Product Change Notice (PCN)

PCN Number: **PCN-0451149R-01**

Product(s) Affected: PJ-037B

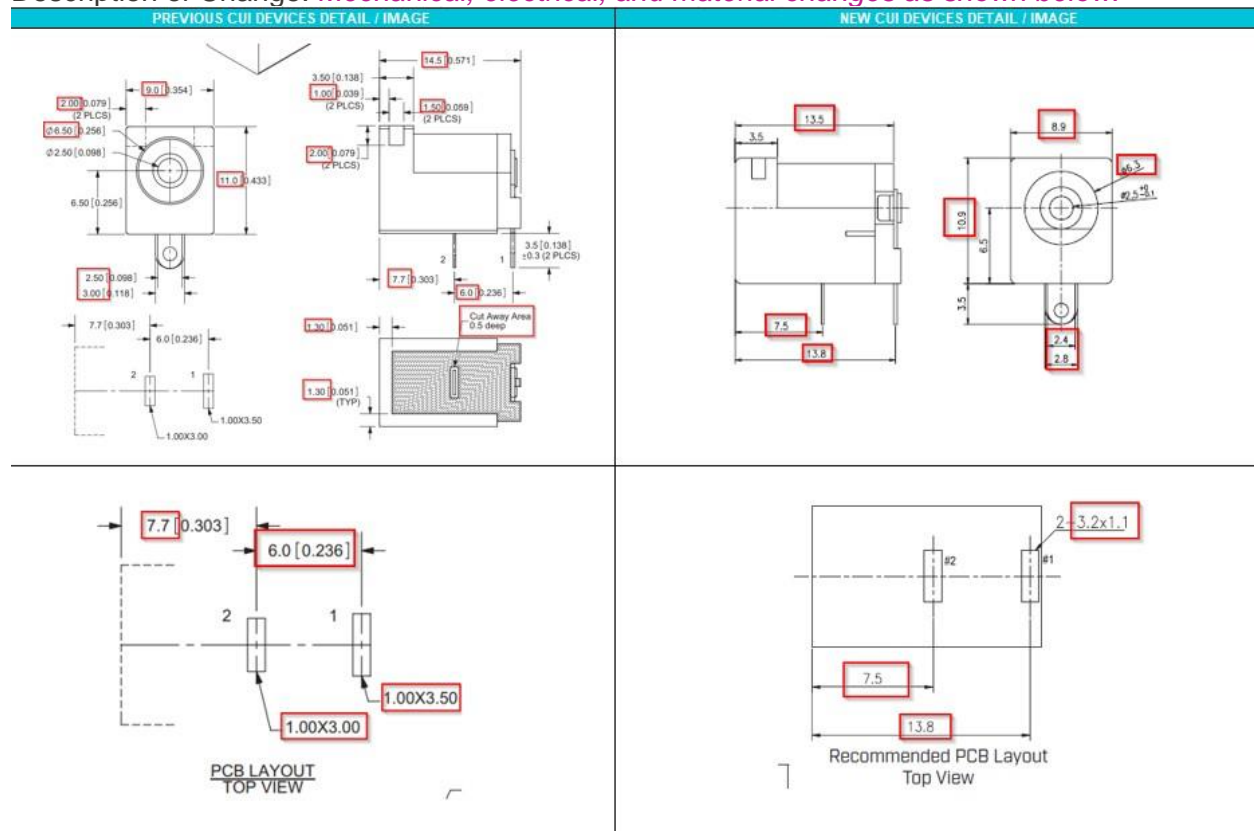
Description of Change: *Mechanical, electrical, and material changes as shown below:*

MATING PLUG
Jack Insertion Depth: **9.0 mm**

MATING PLUG
Jack Insertion Depth: **9.8 mm**

MATERIAL	PLATING
center pin	copper	nickel
terminal 1	brass	tin
terminal 2	copper alloy	tin
plastic	PBT

DESCRIPTION	MATERIAL	PLATING/COLOR
center pin	copper alloy	nickel
terminal 1	brass t=0.3 mm	nickel-silver
terminal 2	phosphor bronze t=0.3 mm	nickel-silver
housing	PBT (UL94V-0)	black
cover	PBT (UL94V-0)	black

Insertion/Extraction force adjusted to 0.3 ~ 2.0Kg
